City of Dublin

Basic Plan Review

13-031BPR – BSC Sawmill Center Neighborhood District

Dublin Village Center – Edwards Apartment Building

Attachment A | Block Labels

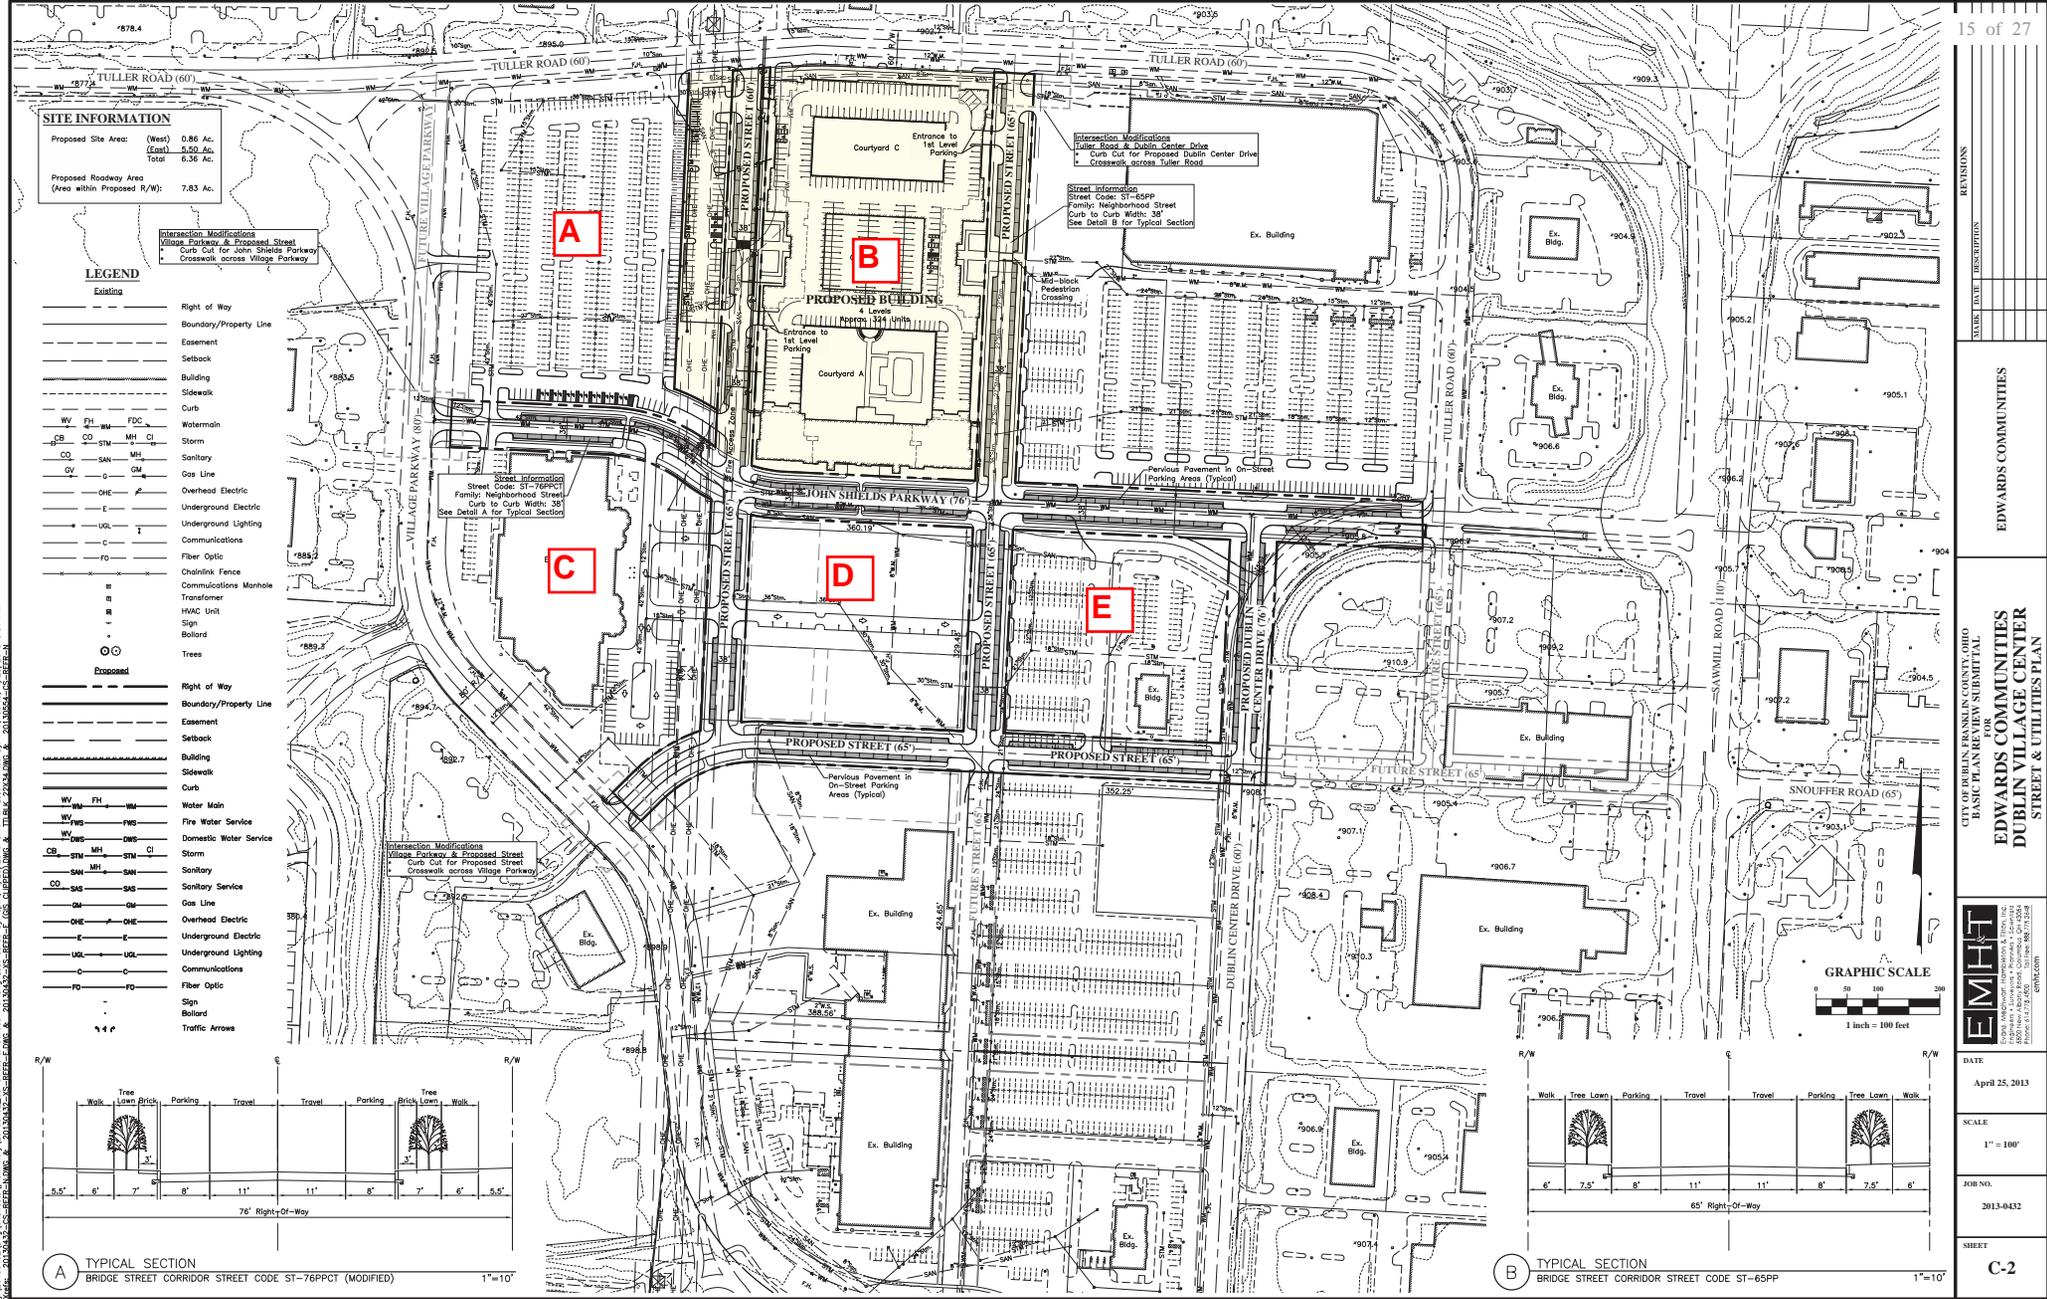
- d. That the applicant work with the property owner to reconfigure the proposed open space to provide the required open space "node" at the intersection of Street Segments 1 and 2, with open spaces (pocket plazas or pocket parks) at a minimum of three, if not all four corners of the intersection and provide the minimum required 1.49 acres of open space on-site and/or within 660 ft. of the development site;

B	Not Met – Development Plan Waiver Required. Max. block length: 661 ft. (exceeds 500 ft. max block length); block perimeter: 2,032 ft. (exceeds 1,750 ft. max block perimeter). Refer to Development Plan Waiver analysis in Part III, Applicable Review Standards.
		C	Not Met – Development Plan Waiver Required. Max. block length: 658 ft. (exceeds 500 ft. max block length); block perimeter: 1,654 ft. (met - does not exceed 1,750 ft. max block perimeter). Refer to Development Plan Waiver analysis in Part III, Applicable Review Standards.
		D	Met. Max. block length: 361 ft.; block perimeter: 1,389 ft.
		E	Met. Max. block length: 358 ft.; block perimeter: 1,376 ft.
(C)(3)(a)	Block Configuration	Met. Blocks generally rectangular in shape.	
(C)(3)(b)	Front Property Lines (FPL)	Administrative Departure Required. Front property lines are required on at least two sides; for Block B, there is only one front property line (along the Principal Frontage Street) and three corner side property lines due to building dimensions, although the intent of the requirement is met.

Attachment B | Street Segment Labels

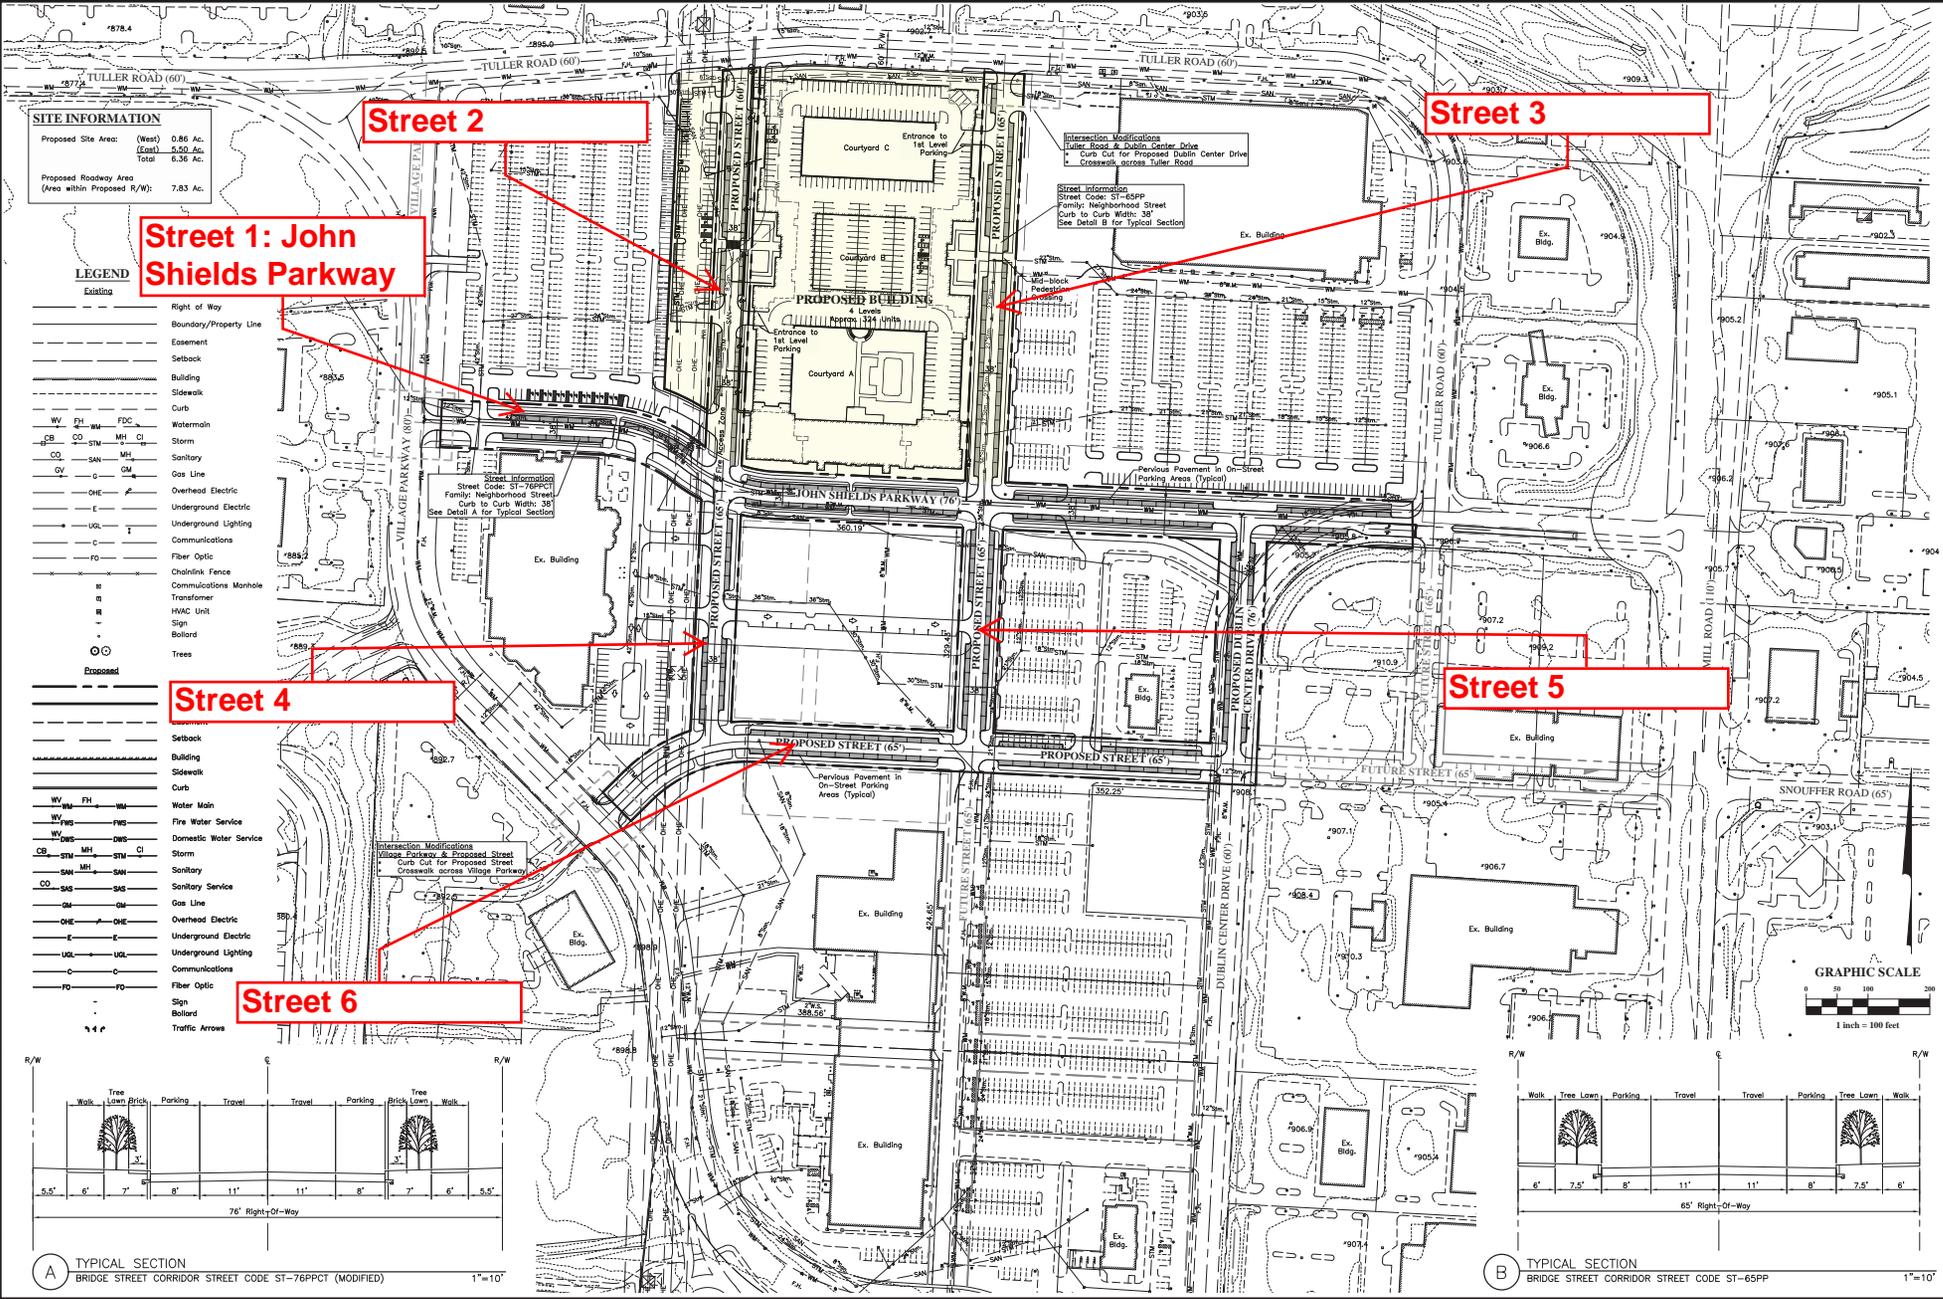
(C)(4)(a)-(c)	Principal Frontage Streets (PFS) <i>(Refer to Attachment B for Street Segment Labels)</i>	1	Met with condition. No vehicular access shown along Street Segment 1 (John Shields Parkway) as part of Edwards development (Block B). Some existing driveways are shown on this street segment resulting from existing conditions; these driveways should be coordinated to direct pedestrian activity and subject to approval by the City Engineer.
		5	Met. No vehicular access requested at this time; if the one-way street conceptually illustrated on the plans is proposed as part of a future

N/A. Sign Plans: None proposed for the Edwards project, but may be requested as part of a future graphics plan for this site and/or adjacent development.
		Met with Condition. Street Terminations: The curve shown in Street Segment 1 (John Shields Parkway) at the southwest corner of Block B creates an opportunity for a terminal vista. Heightened architectural detailing and an open space node should be provided at this intersection.
		N/A. Gateways: A gateway element should be provided at the intersection of the new John Shields Parkway and Village Parkway once future redevelopment plans for the Dublin Village Center move forward.
(C)(6)	Open Spaces <i>Refer to 153.064, below.</i>	Met with Condition. (a) Character & (d) Network: The BSC Sawmill Center Neighborhood District is intended to accommodate a wide variety of building types and uses to create a vibrant, mixed use shopping and entertainment environment with pockets of residential development located in proximity, accented by a high quality open space network that balances a variety of natural and hardscape areas designed to provide intimate gathering spaces appropriate for an urban setting.
